UNITED STATES PATENT AND TRADEMARK OFFICE

Office Action Summary	Application No. 10/695,377	Applicant(s) MELCHER, THOMAS WESLEY	
	Examiner Eric Culbreth	Art Unit 3616

DETAILED ACTION

FIG. 2A

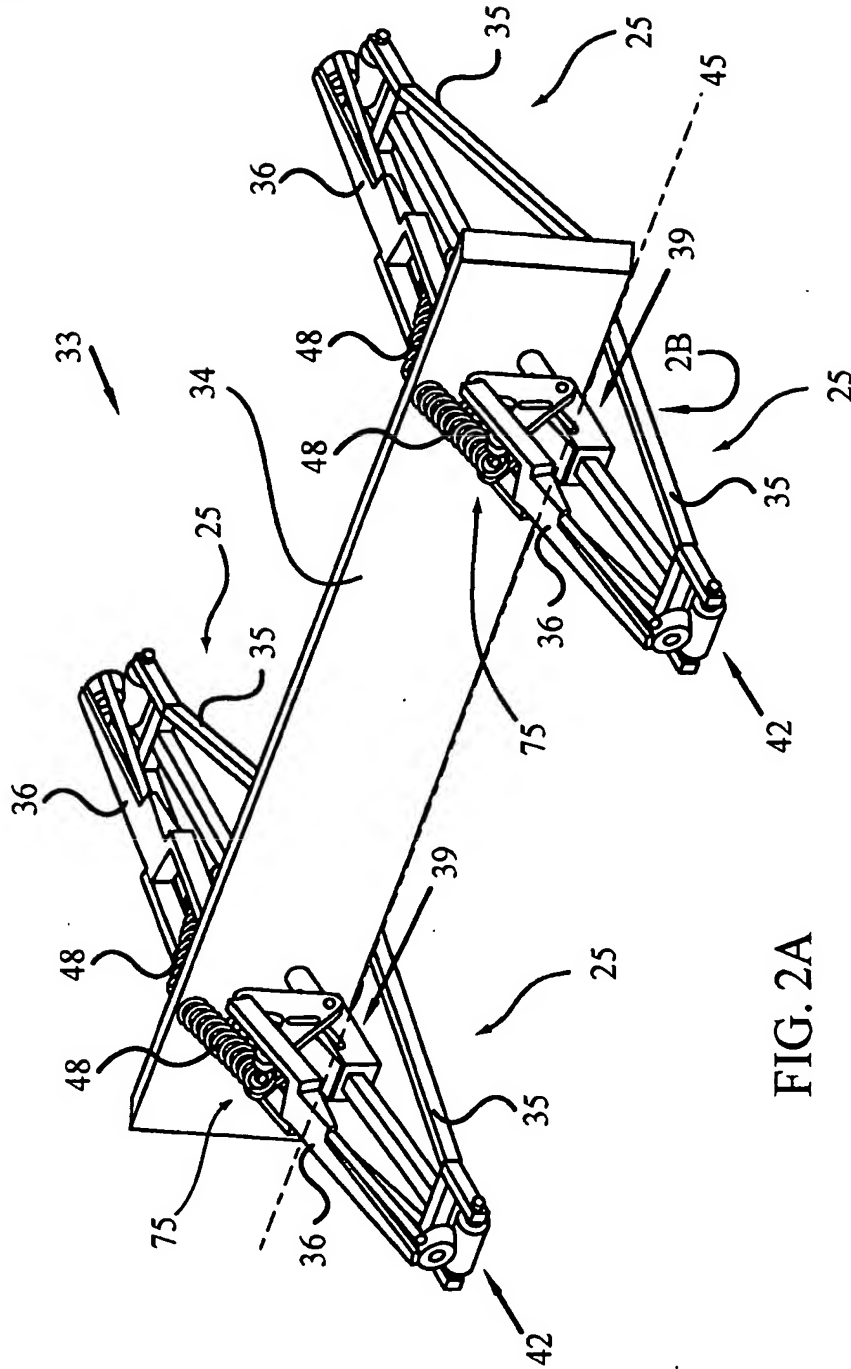
On page 15 of the remarks, the applicant argues that feed forward is at least inherent on a system incorporated with a mechanical shock absorber, and that feed forward is shown by different compression of the shock absorber on opposite sides of the frame in Figures 1A and 2A. However, this would not result in feed forward. As even pointed out by applicant's own Exhibit A (Wikipedia), in the second paragraph on page 1, a prerequisite for feed forward control is that the time it takes for the disturbance to affect the output must be longer than the time it takes for the feedforward controller to affect the output. This would not be true in applicant's invention, even with an electric controller, as the system is already affected when the shock absorber moves or is disturbed. Hence, contrary to the definition in applicant's own exhibit, the

Not Approved
EL
2/3/06
